Access Compliance Report

Public Rights-of-Way

Intersection ID: 53253	Main Street: MARLOWE_AV	Cross Street: ALYSSA_LN	Location: NW
ADA ID: DD33C91B4E59	Ramp Type: BlendTrans1	Initial Pass/Fail: Fail	Overall Compliance: No
Severity Score: 8.75			
Codes/Mitigation Info/Possible Solution		Field Measurements/Component Compliance

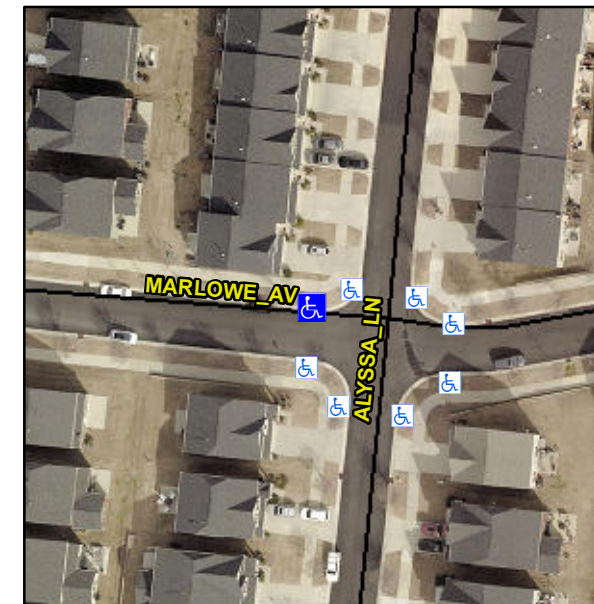
Not Found, R304.5.1

Compliance	Description	Data	Compliance	Description	Data
N/A	Ramp Length (in)	96.0	Yes	BlendTrans Slope (%)	1.2
No	Ramp Width (in)	47.0	Yes	BlendTrans XSlope (%)	0.7
N/A	Flare Type LT	N/A	N/A	Flare Type RT	N/A
N/A	Flare Slope LT (%)	N/A	N/A	Flare Slope RT (%)	N/A
N/A	Flare Traversable LT?	N/A	N/A	Flare Traversable RT?	N/A
N/A	Landing Length (in)	N/A	N/A	DWS Provided?	N/A
N/A	Landing Width (in)	N/A	N/A	DWS Contrast?	N/A
N/A	Landing Slope (%)	N/A	N/A	DWS Length (in)	N/A
N/A	Landing X Slope (%)	N/A	N/A	DWS Full Width?	N/A
N/A	Landing Curb? (Y/N)	N/A	N/A	DWS Offset (in)	N/A
N/A	Shared Landing?	N/A			
N/A	Gutter Ponding?	N/A	N/A	Gutter Slope (%)	N/A
N/A	Gutter Lip Ht (in)	N/A	N/A	Gutter X Slope (%)	N/A
N/A	Painted X Walk1?	No	N/A	Painted X Walk2?	N/A
	X Walk 1 Direction	To S		X Walk 2 Direction	N/A
	X Walk 1 Width (in)	N/A		X Walk 2 Width (in)	N/A
	X Walk 1 Slope (%)	8.3		X Walk 2 Slope (%)	N/A
	X Walk 1 X Slope (%)	1.5		X Walk 2 X Slope (%)	N/A

N/A	Ramp inside XWalk1?	N/A	N/A	Ramp inside XWalk2?	N/A
	Road Slope (%)	1.5		Clear Space?	N/A
	Road X Slope (%)	8.3	N/A	Clear Space to XWalk (in)	N/A
N/A	Any Obstructions?	N/A	N/A	Storm Grate/Utility Hazard?	N/A
	Obstruction Type			Storm Grate/Utility Type	
		N/A			N/A
			Yes	Surface Condition? (G/P)	Good
			No	Curb Slope (%)	10.9

Remove & Replace Curb Ramp With Two New Directional Ramps or Equivalent.
